DESCRIPTIVE REPORT

Type of Survey ... Hydrographic .....  
Field No. .... FA-20-2-85 .....  
Registry No. .... H-10197 .....

State ..... Alaska .....  
General Locality .. South Entrance to Shelikof...  
Strait  
Sublocality ..... 7 Miles East of Agripina Bay.

SUBJECT: Preprocessing Examination of H-10197, Alaska,  
Southern Entrance to Shelikof Strait, South of Kilokak Rocks

ATTACHMENT A

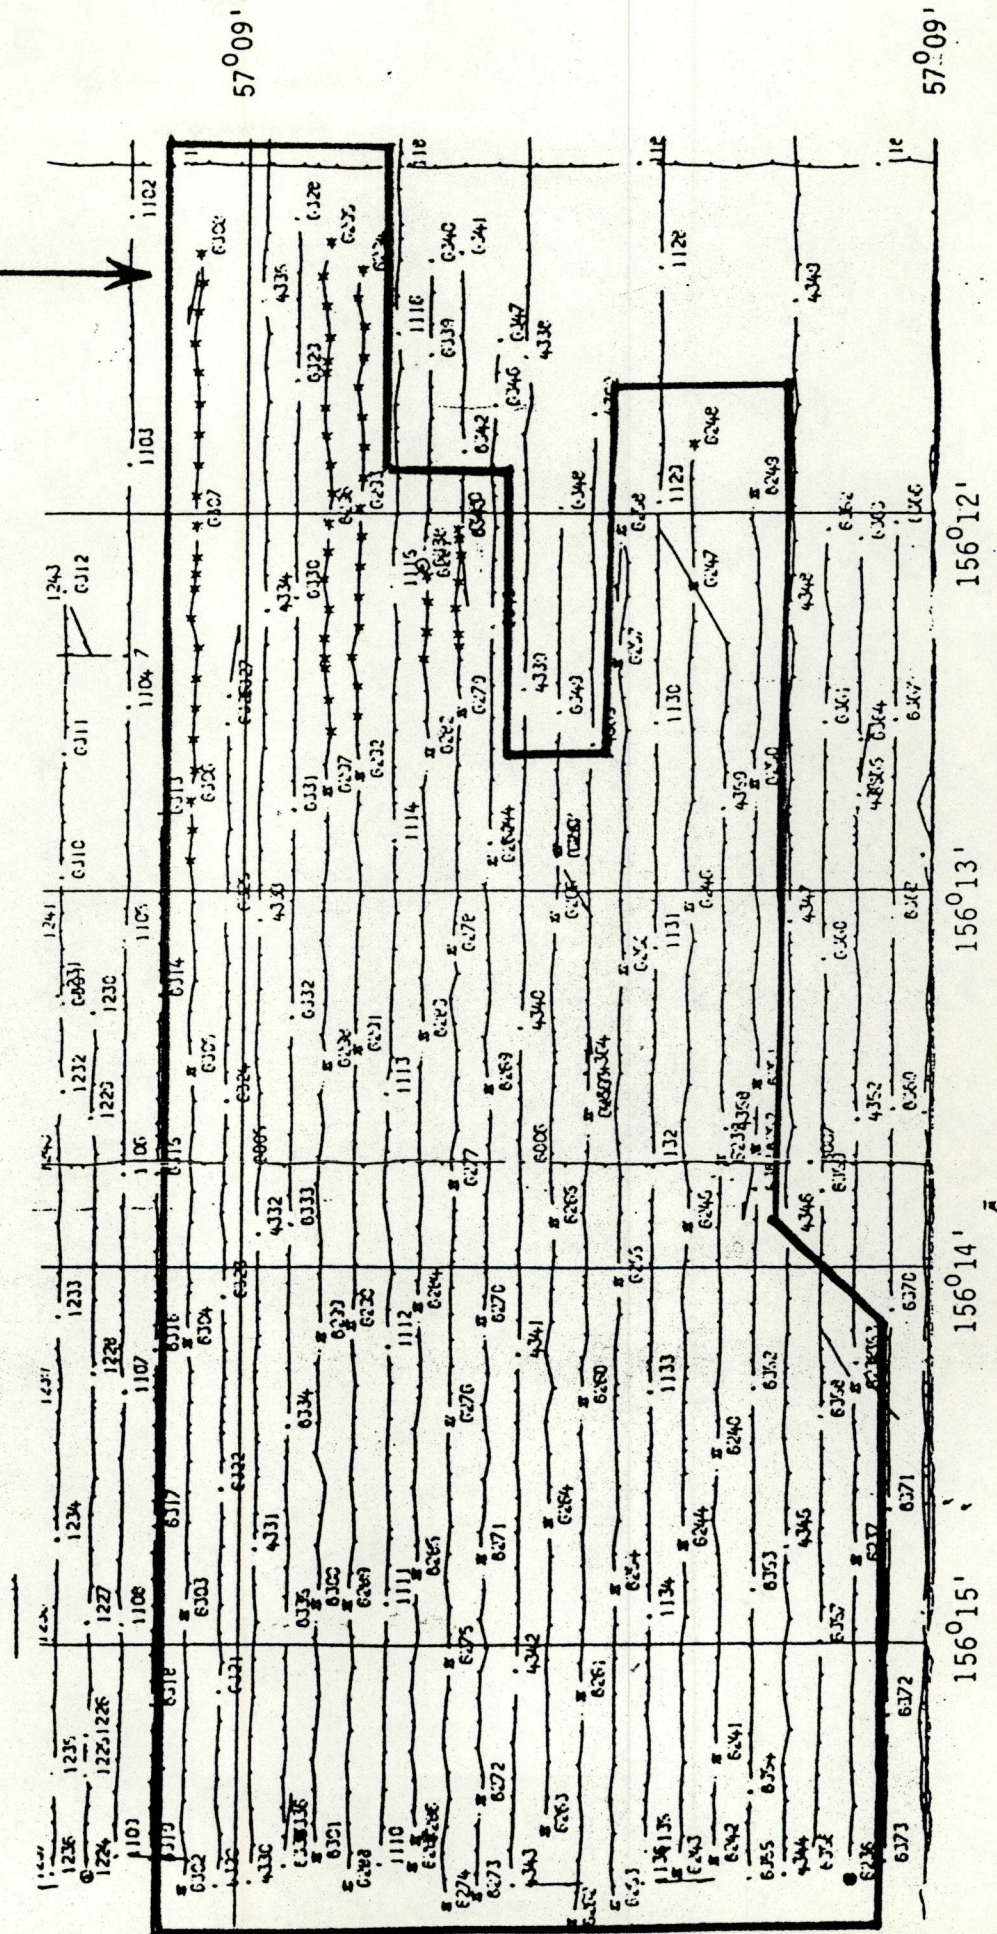
Poor intersection angles (less than 30 degrees or greater than 150 degrees) were found for 97 positions covering 30 nm of sounding lines (see Attachment A). The minimum angle of intersection should not be less than 30 degrees (HM 4.4.3.2.2).
